Sure Power Battery Equalizer **RECALL**

Models Affected: 2004 Ultra LMB (L3RE), 2003-2006 Ultra LF (L4RE), 2004-2007 Express (M4RE)

RECALL CAMPAIGN R13WN

Express Equalizer Located Curb Side On RH Side Above The Battery Tray

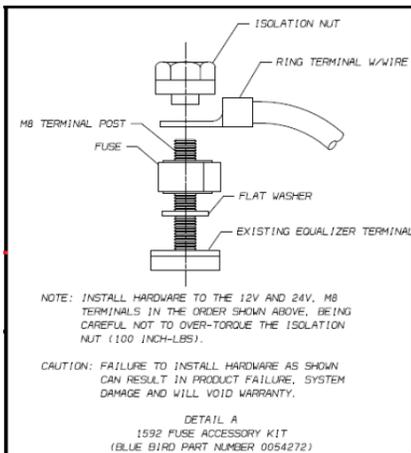
3. Locate the Sure Power battery equalizer. See detail views on page 2 for location by product type.
4. The battery equalizer must be inspected and the serial number, date inspected and body number or vehicle identification number recorded on the attached Recall R13WN Inspection Reply Sheet.

There is only one label location on the product as shown in the picture below, with the serial number in the white section on the end opposite the terminals:

- e. Install flat washer and fuse removed in step “b” (see detail A).
 - f. Install isolation nut removed in step “a” (see detail A on page 2) and torque to 100 inch-lbs. **Be careful not to over-torque**
